**Report Type:** DA Access Report  
**Reference Number:** 18283  
**Client:** St Dominics College c/o PMDL  
**Site Address:** 54-94 Gascoigne Street, Kingswood NSW

# ACCESS REPORT

This Access Compliance Report is to accompany a Development Application for the development proposed at 54-94 Gascoigne Street, Kingswood NSW.

This development proposes a New Building identified as Block E within an existing High School (St Dominics College). The development is within Penrith Council LGA. A total of 1 Accessible parking space has been provided within the new section of the development.

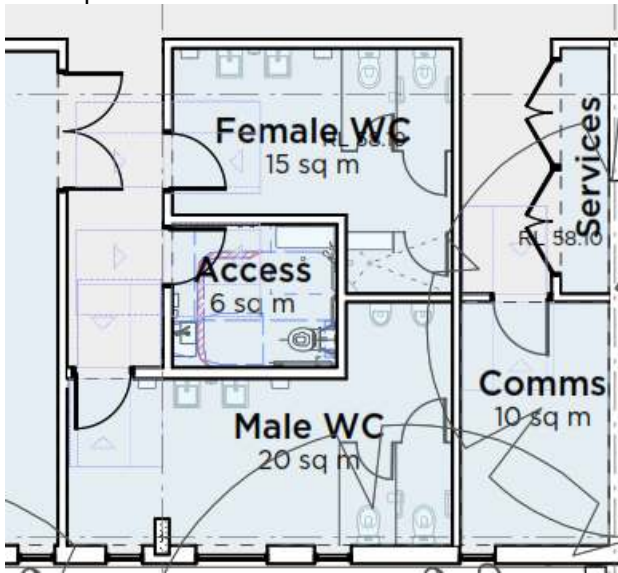
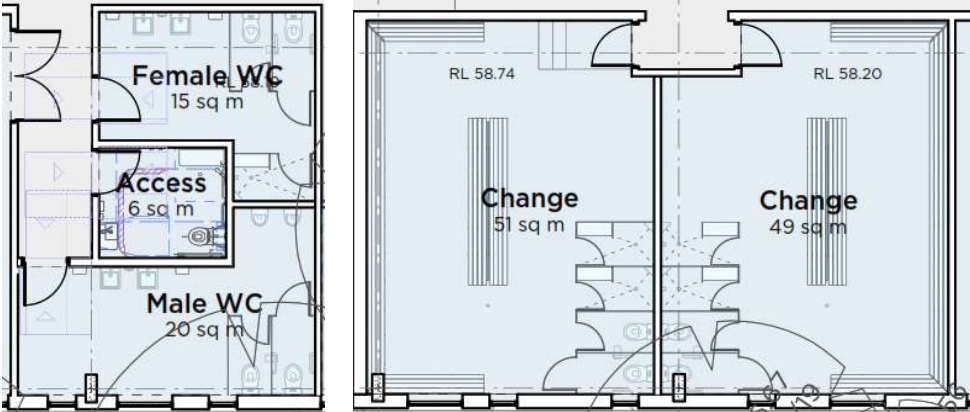
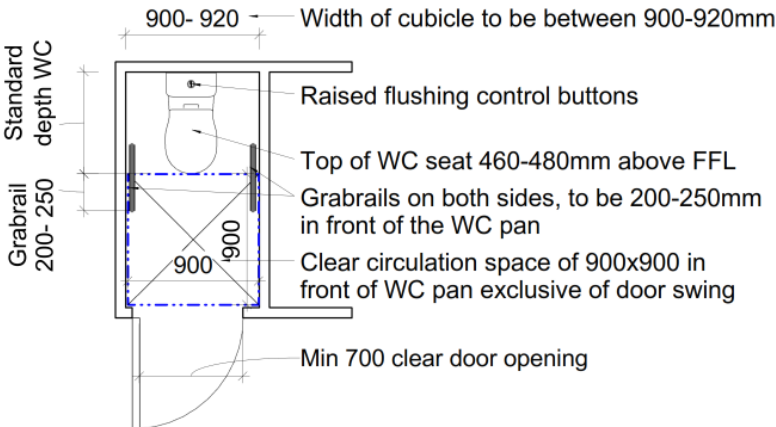
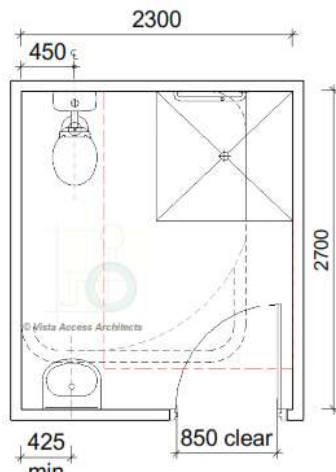
<b>Compliance Comments</b>	Complies. The auditorium has been designed as tiers of seating and not individual seats. In this case wheelchair users are able to choose their locations at the base of the tiers (accessed via the ground level) as shown below. Or alternatively at the top of the tiered seating ( accessible via a lift to first floor) as shown below.
----------------------------	---

Access via ground floor level

Access via first floor level
